1370 STEWART ST

PRIORITIES & BOARD RECOMMENDATIONS

After visiting the site, considering the analysis of the site and context provided by the proponents, and hearing public comment, the Design Review Board members provided the following siting and design guidance.

SECTION 2
THE TOWER

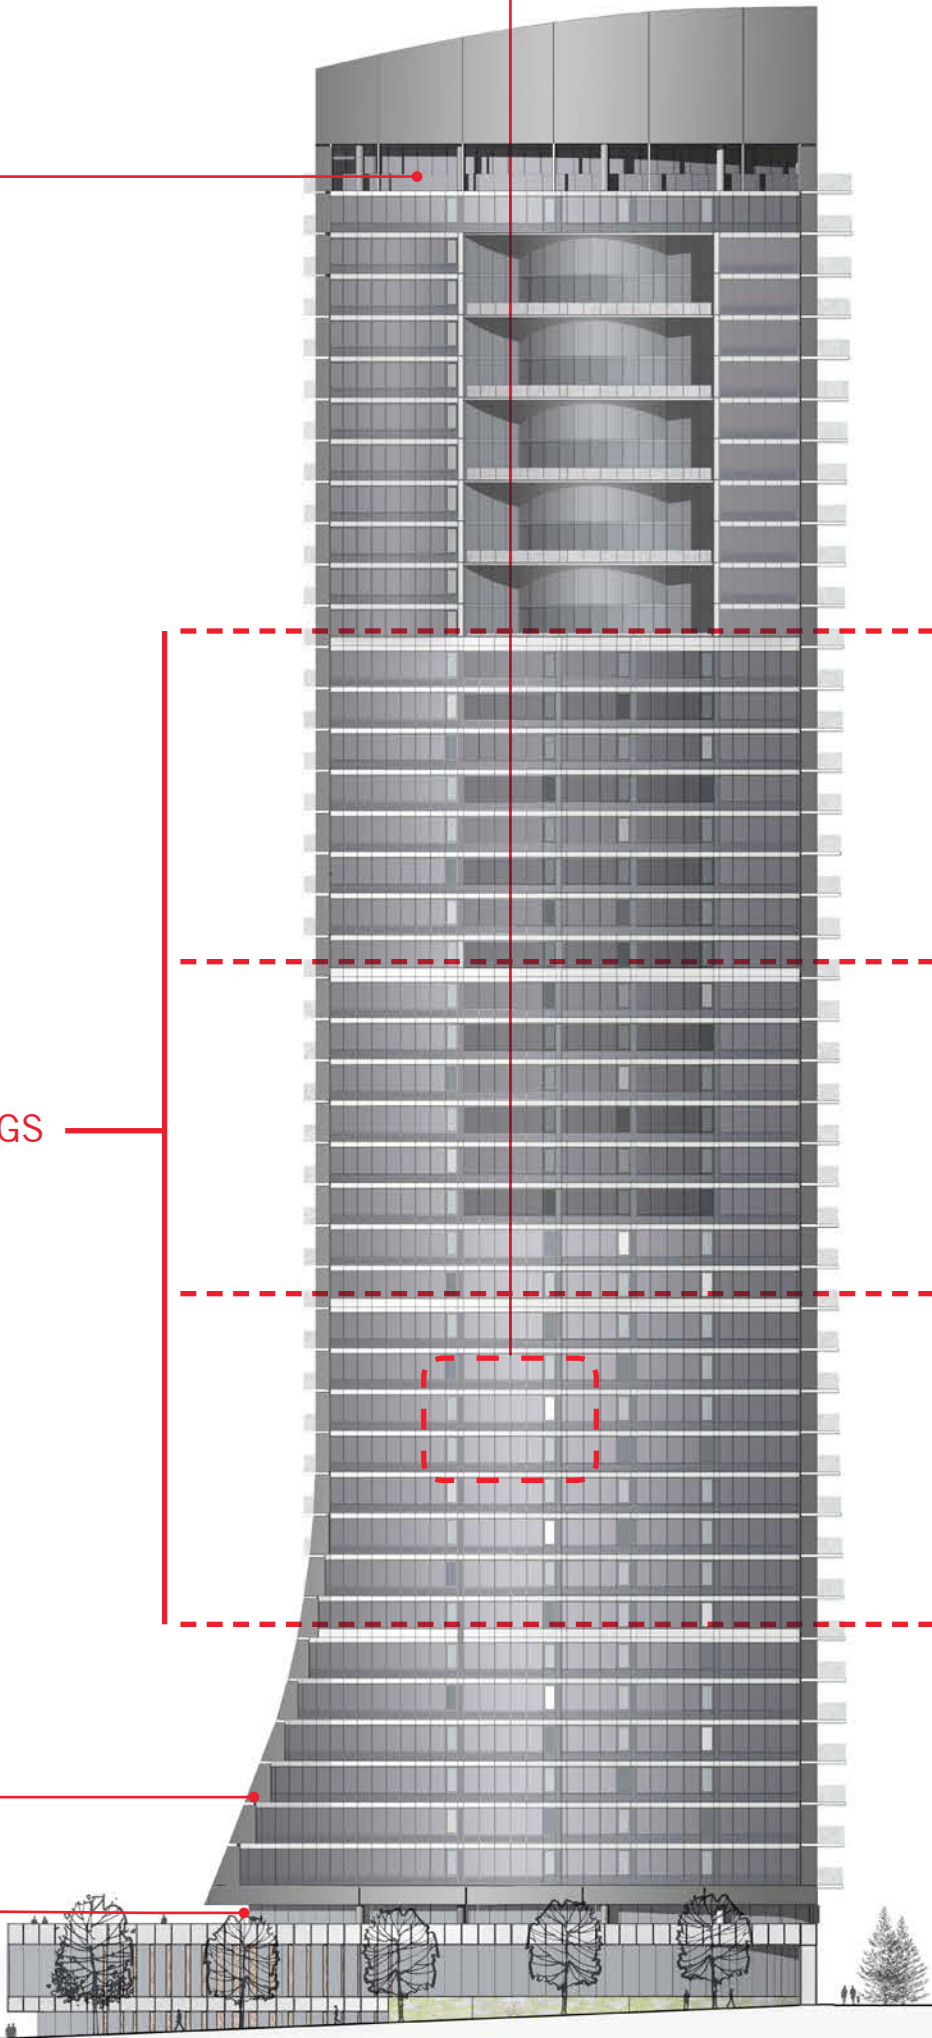
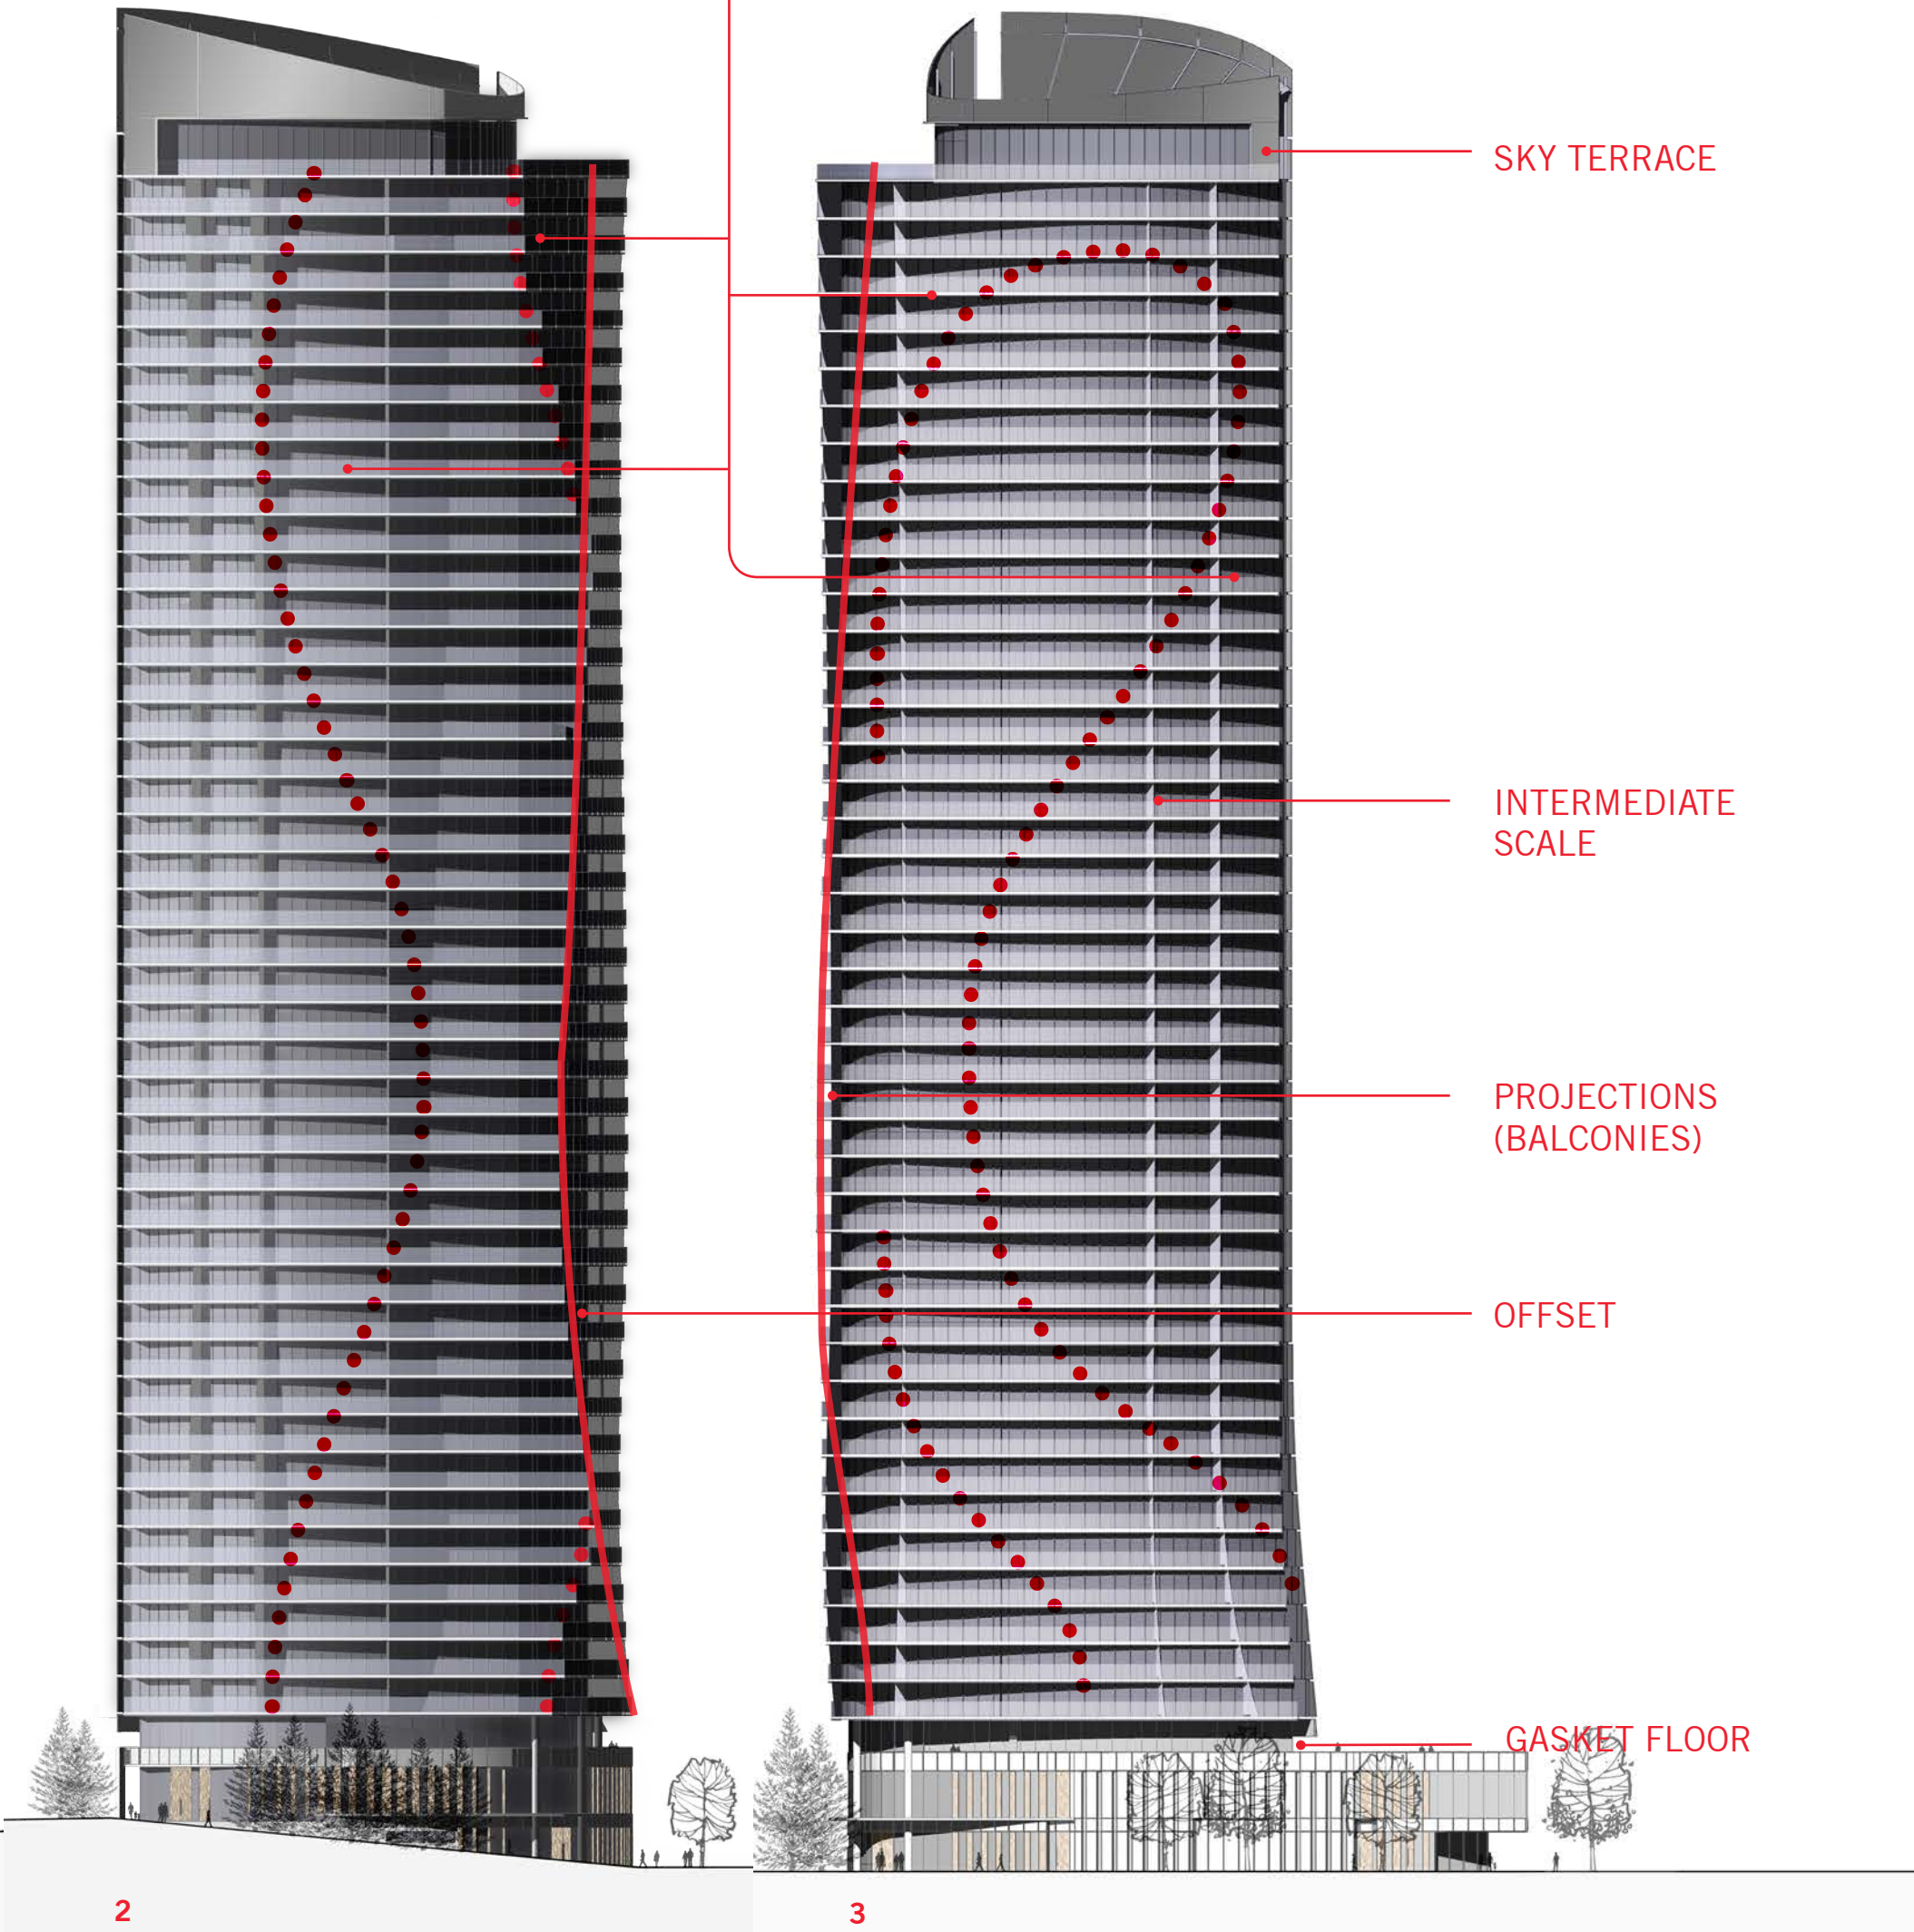
- 2A.** The Board expressed their appreciation for the conceptual thinking behind the tower form and found the preferred scheme to be logical, simple and elegant. (DC2- A, DC2-1)
- 2B.** The Board pointed out how the change in cladding and strong horizontal banding on the east facade had created intermediate scale elements (as called for in the SLU guidelines) and asked that the other two (north and west) elevations also include intermediate scaling elements (though not necessarily the same). (DC2-4-d., DC2-1, DC2-B, DC2-C)
- 2C.** The Board was concerned that the contrast between the east-facing façade and the two west-facing facades was so strong as to seem disconnected and asked that this contrast be resolved as the design evolves. (DC2-B, CS3)

Undulating projections and offsets form a dynamic massing. An intermediate scale is organically created through floors which are grouped together from the shadows produced.

Continuity between the facades is created through the overall contemporary design language, more specifically the continuity is maintained through complementary geometry and materials.

THE PODIUM + THE TOWER

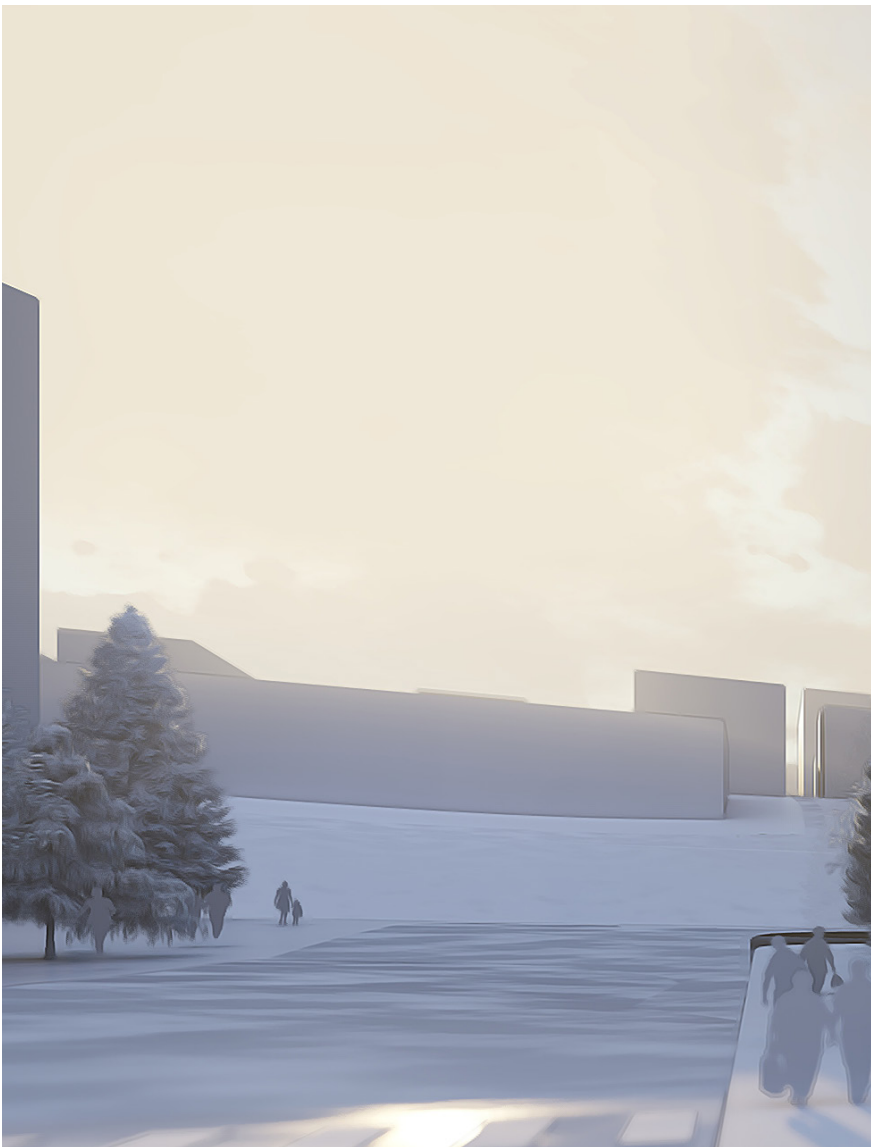
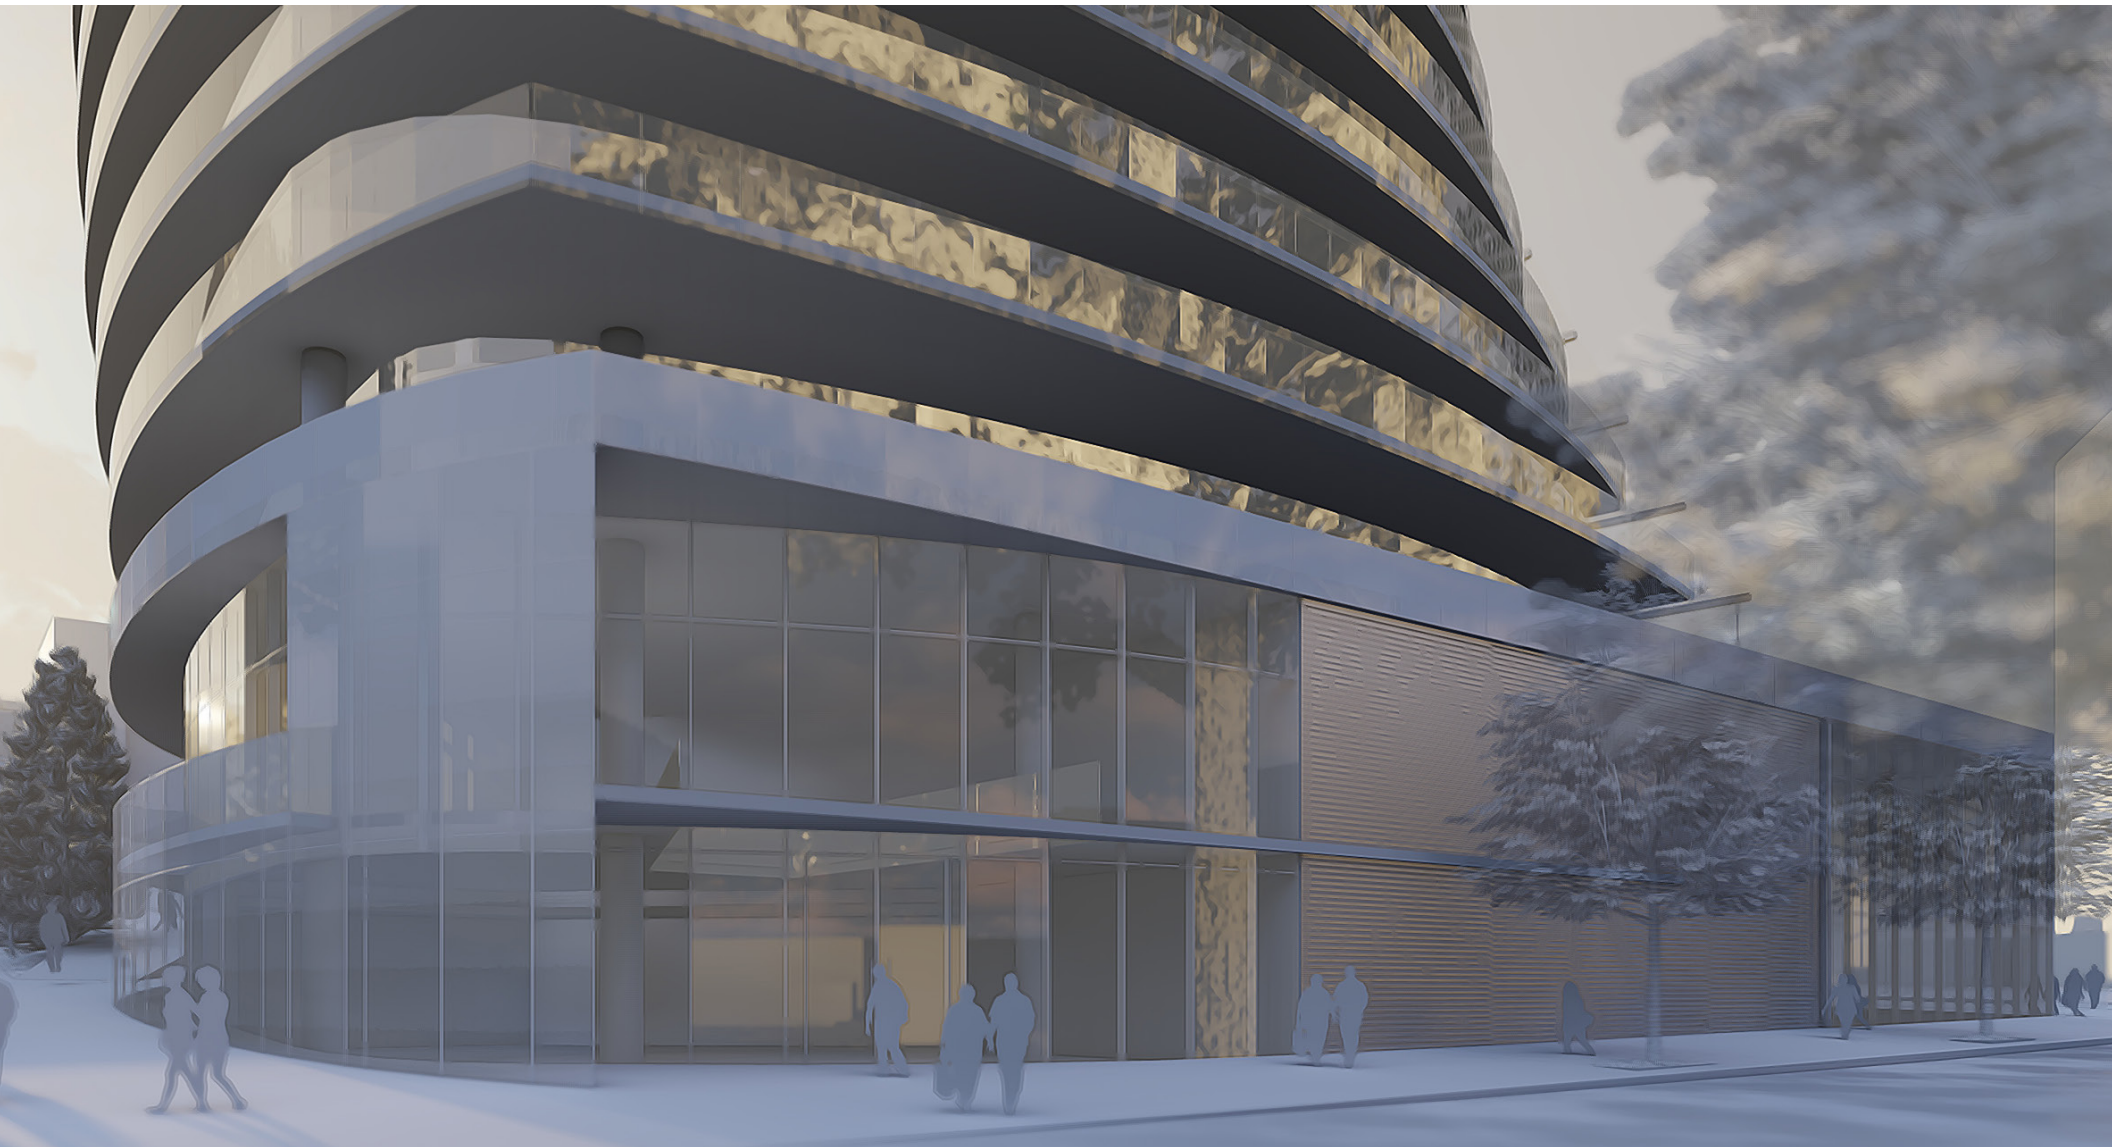
3A. The Board agreed that the northwest corner of the site will be the locus of pedestrian activity and expressed concern both that the mass of the tower is concentrated at this corner and that the podium-tower relationship is weakest here.(CS2-4, DC2-4)

- i. The Board did not support the tower coming to grade at this corner as the important scaling element of the podium would be lost. (DC2-3-a)

- 1. Express Podium / Response to Context
- 2. Facade Depth & Articulation
- 3. Exposed Columns
- 4. Canopy - Human Scale Elements
- 5. Pedestrian Oriented / Building Open Space Relationship
- 6. Intermediate Scales
